**SUBJECT:** Safety Recall 05S28 - Supplement #2  
Certain 2000 Model Year F-150, Expedition, Navigator, and 2001 F-150 SuperCrew  
Vehicles Equipped With Speed Control  
Speed Control Deactivation Switch Replacement

## CERTAIN 2000 MODEL YEAR F-150, EXPEDITION, NAVIGATOR AND 2001 F-150 SUPERCREW VEHICLES EQUIPPED WITH SPEED CONTROL OPTION — SPEED CONTROL DEACTIVATION SWITCH REPLACEMENT — INTERIM REPAIR

**SUBJECT:** Safety Recall 05S28 - Supplement #3  
Certain 2000 Model Year F-150, Expedition, Navigator, and 2001 F-150 SuperCrew  
Vehicles Equipped With Speed Control  
Speed Control Deactivation Switch Replacement

**CERTAIN 2000 MODEL YEAR F-150, EXPEDITION, NAVIGATOR AND CERTAIN 2001 F-150 SUPERCREW VEHICLES — SPEED CONTROL DEACTIVATION SWITCH REPLACEMENT**

FIGURE 1

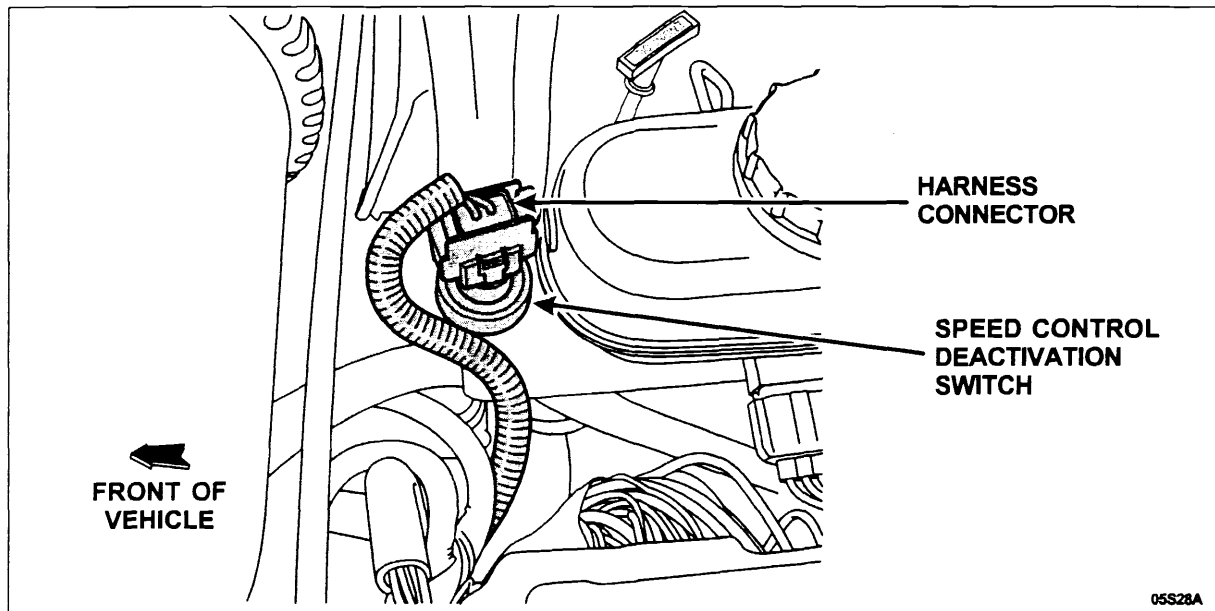
1. Disconnect the electrical connector from the speed control deactivation switch which is located on the brake master cylinder. See Figure 1.

A. No. The Speed Control Deactivation switch is mounted to the brake master cylinder under the hood, and is not located on the steering wheel (see Attachment III, Figure 1).

FIGURE 2

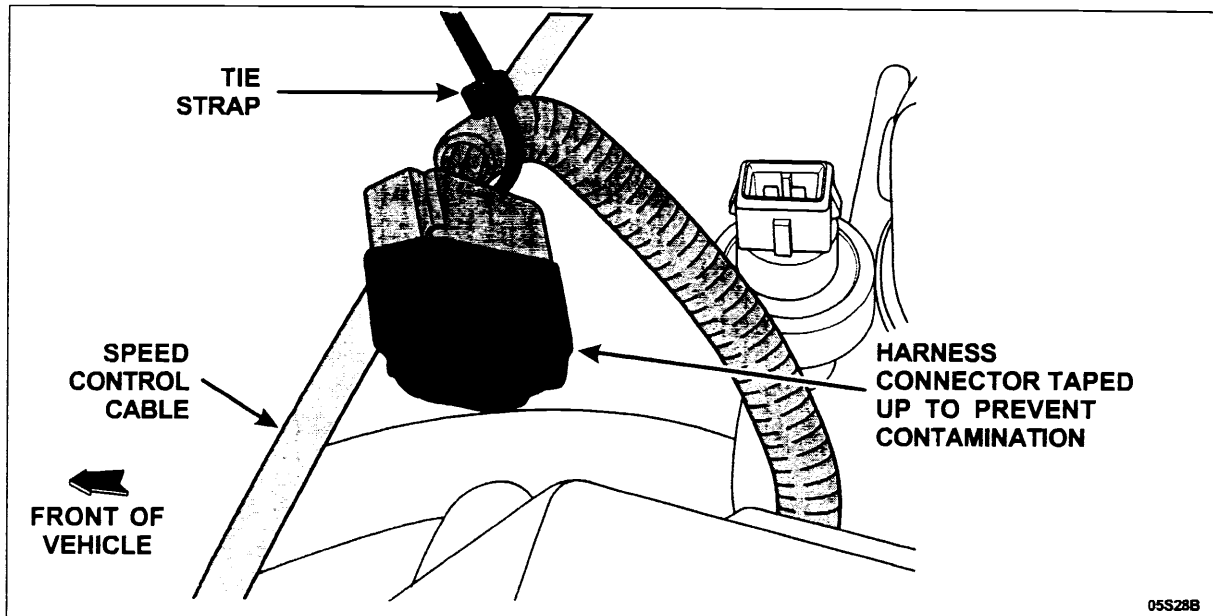
2. Using vinyl tape, tape closed the end of the deactivation switch harness connector to prevent contamination from entering the connector.
3. Secure the connector by tie strapping it to the speed control cable or another available location to prevent rattle or contact with other components. Keep the harness away from the power distribution box to avoid chafing the harness. See Figure 2.

**FIGURE 1**

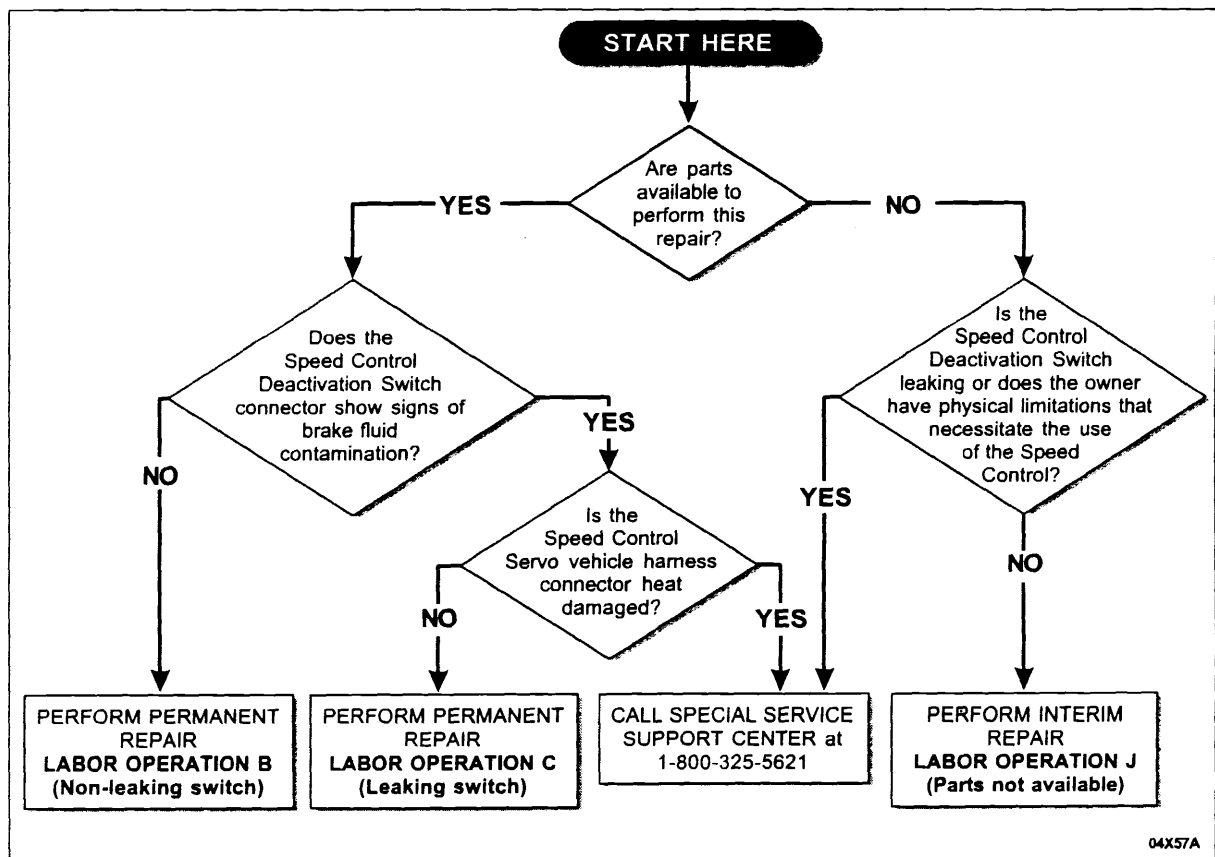
This program involves performing certain inspection procedures to determine which repairs to the speed control system must be performed. A flow chart has been developed to direct you to the proper service actions. See Figure 1.

**FIGURE 2**

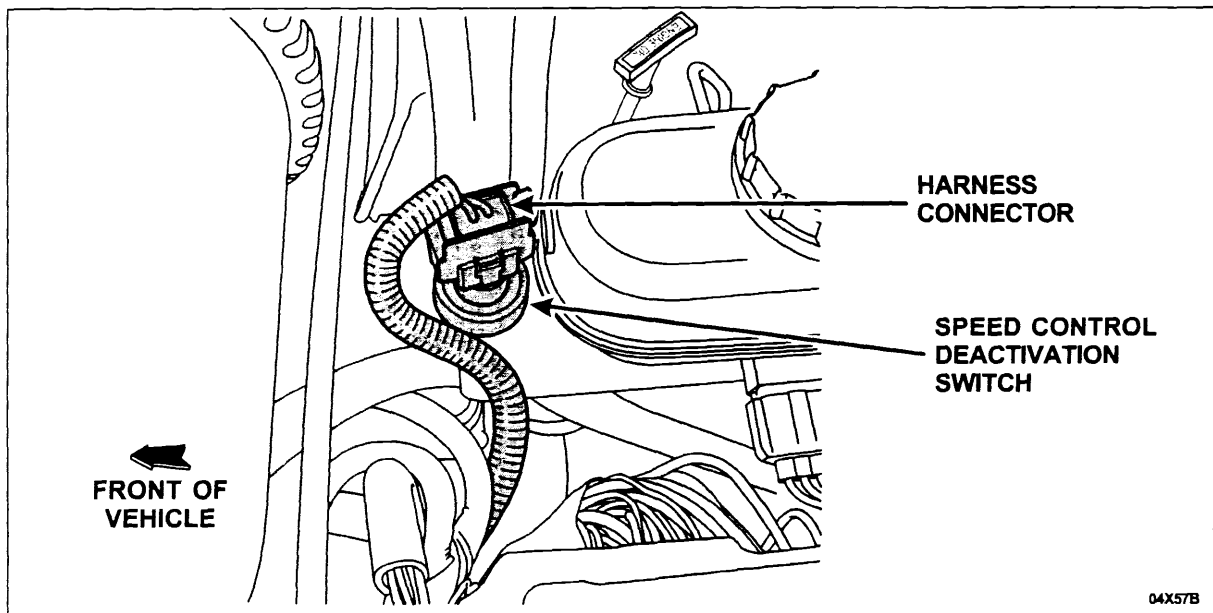
2. Install a memory saver and disconnect the battery negative terminal.
3. Disconnect the Speed Control Deactivation Switch located on the brake master cylinder and inspect the harness connector for the presence of brake fluid. See Figure 2.

- If no brake fluid is present, proceed to Labor Operation B – Repair for a Non-Leaking Switch.
  - If brake fluid is present, disconnect the Speed Control Servo and inspect the vehicle harness connector for heat damage.

- If no heat damage is found (even if there is presence of brake fluid in the connector), proceed to Labor Operation C – Repair for a Leaking Switch.

- If the connector is heat damaged, call the Special Service Support Center at 1-800-325-5621 for further instructions.

FIGURE 4

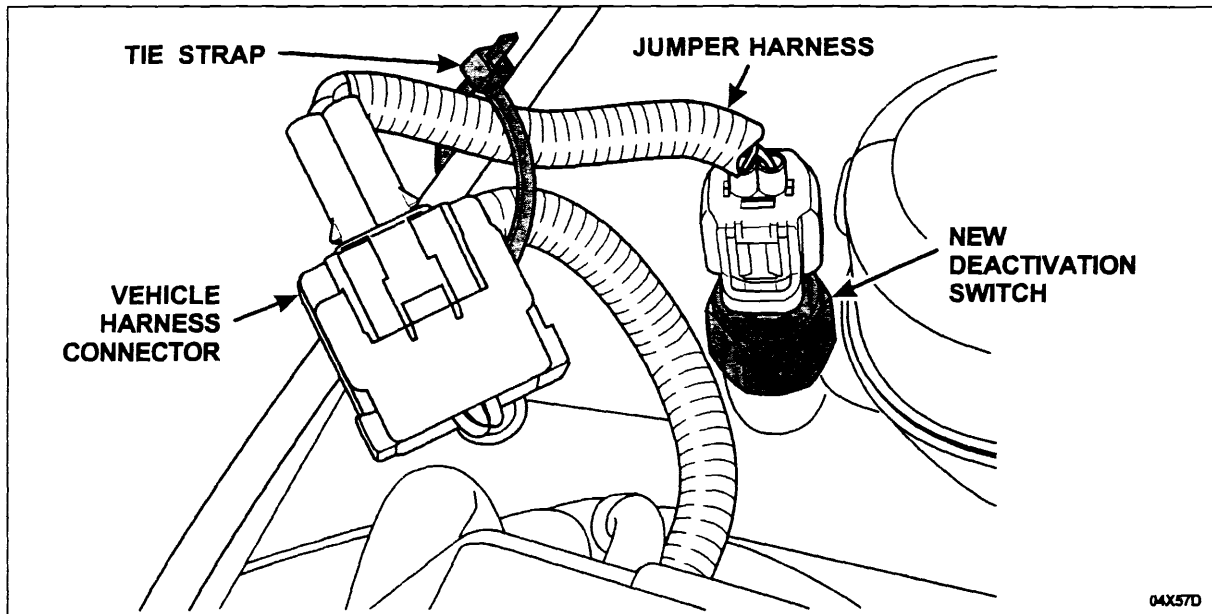
3. Install the *new* deactivation switch into the master cylinder and tighten to 18 Nm (13 lb-ft).
4. Install the supplied jumper harness between the vehicle harness connector and the *new* switch.

5. Using the supplied tie strap, secure the jumper to the speed control cable or some other stationary object. Keep the harness away from the power distribution box to avoid chafing the harness. See Figure 4.
6. Check the brake fluid level in the master cylinder and adjust if necessary.
7. Connect the battery cable and remove the memory saver.
8. Release the vehicle.

FIGURE 5

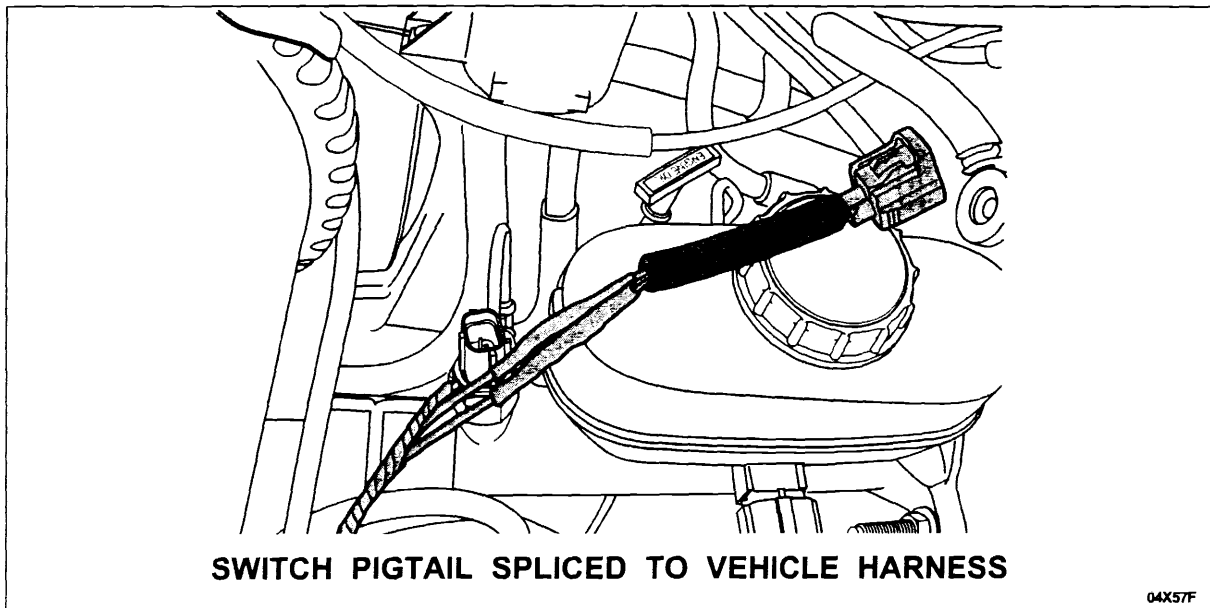
Add a few drops of Motorcraft High Performance DOT 3 Brake Fluid, PM-1, to the fluid port at the threaded end of the **new** deactivation switch. See Figure 5.

FIGURE 7

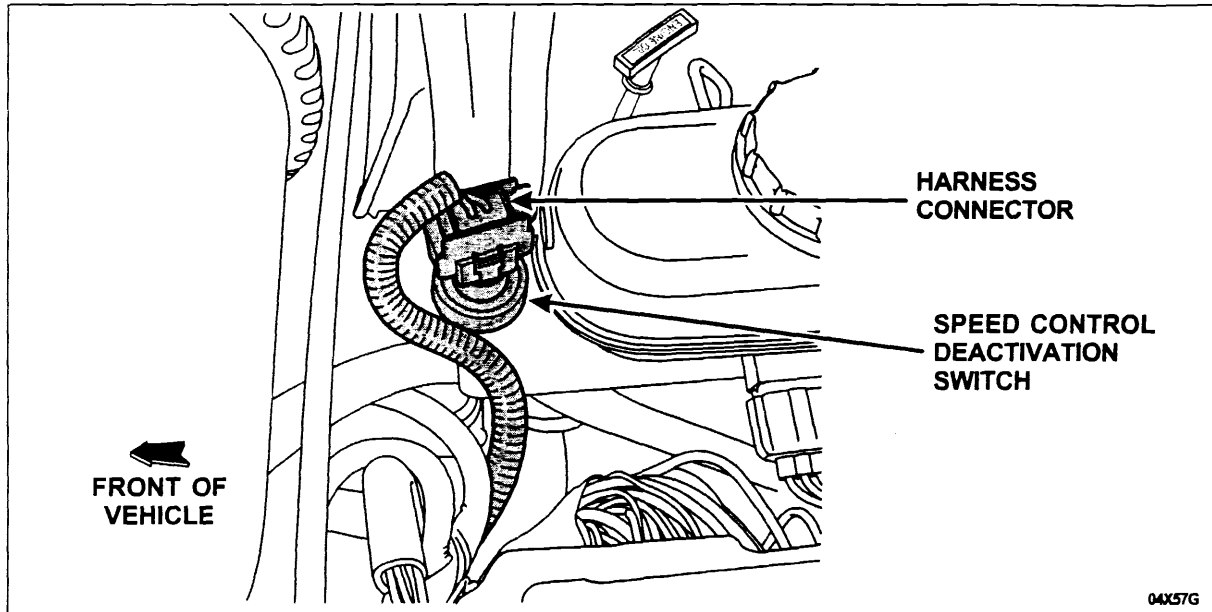
1. Install a memory saver and disconnect the battery negative terminal.
2. Disconnect the Speed Control Deactivation Switch located on the brake master cylinder. See Figure 7.

3. If the switch is leaking (brake fluid is present inside the connector), call the Special Service Support Center at 1-800-325-5621 for further instructions.
4. Using vinyl tape, tape closed the end of the Speed Control Deactivation Switch vehicle harness connector to prevent contamination from entering the connector.

FIGURE 8

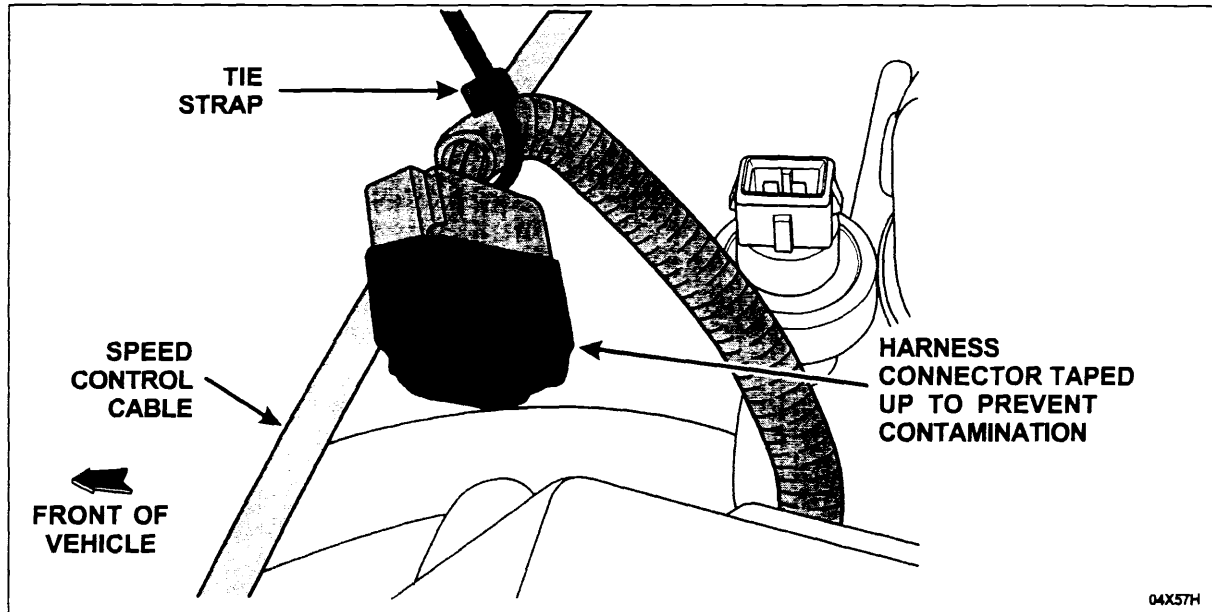
5. Secure the harness/connector by tie strapping it to the speed control cable or some other stationary object. Keep the harness away from the power distribution box to avoid chafing the harness. See Figure 8.
6. Connect the battery cable and remove the memory saver.
7. Release the vehicle.
